Re: The Haven Amphitheatre Committee's proposal for stage and associated works for the Haven Amphitheatre

The Haven Amphitheatre Committee's proposal for stage and associated works for the Haven Amphitheatre

BELOW: The tree ferns are a very important aspect of the Haven Amphitheatre's ambience. They also delineate the creek and separate the original 1930s seating group (in the photo's foreground) from the more recent 1970s and 1990s seating.

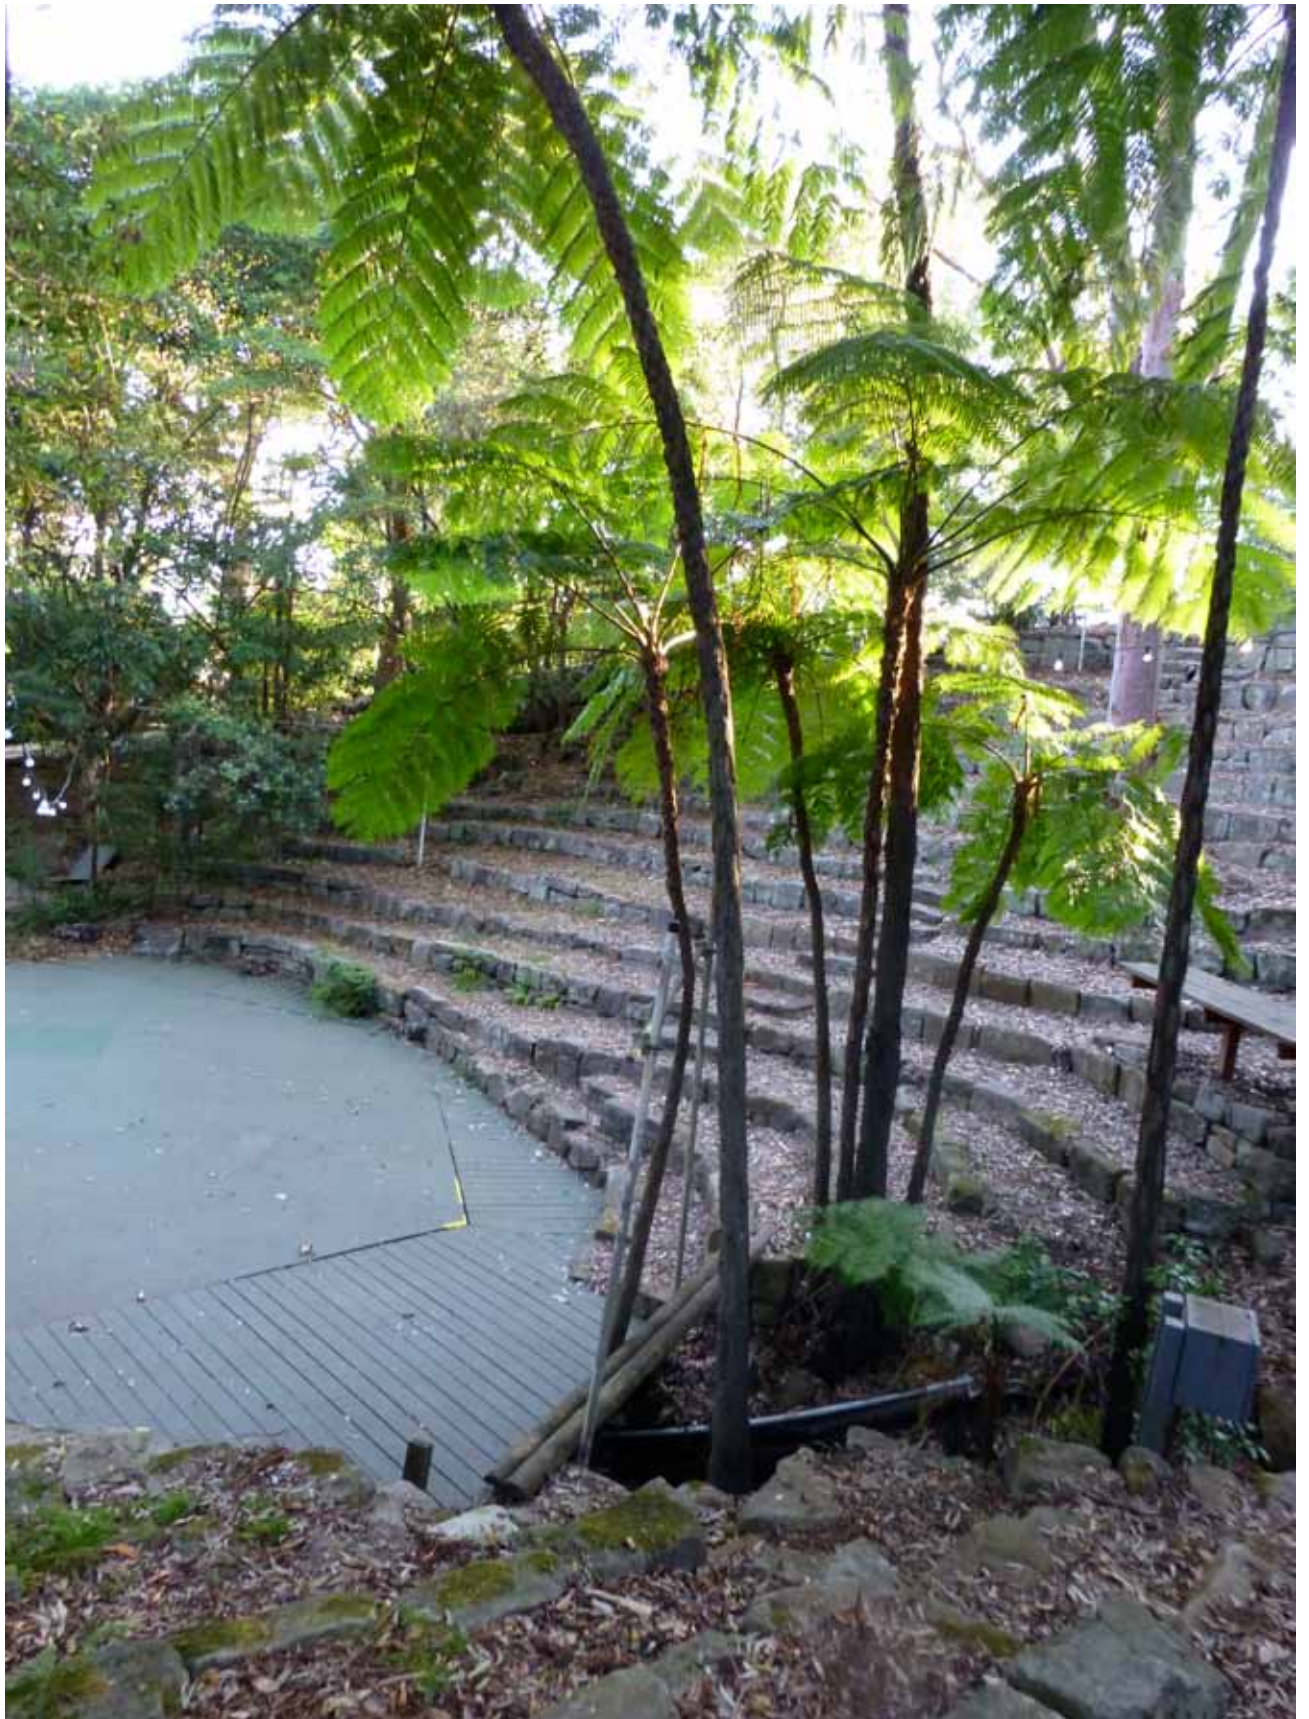
It is the unconventionality of the Haven Amphitheatre that makes it so special. The grouping of tree ferns, located where these seats are proposed, is an important element of the amphitheatre, its amenity and ambience. The two distinct groups of tiered sandstone seats are part of the historic heritage of the site. Joining them together with new seats would confuse the heritage and understanding of the original 1930s seating on the western side and the group of 1970s and 1990s seating on the northern side.

The HAC proposal does not present a rationale for increasing the number of seats. Increasing the seating would change the whole visual character of the amphitheatre and impact on its heritage. In particular, the creek is a particularly important element and needs to be respected in its natural state.
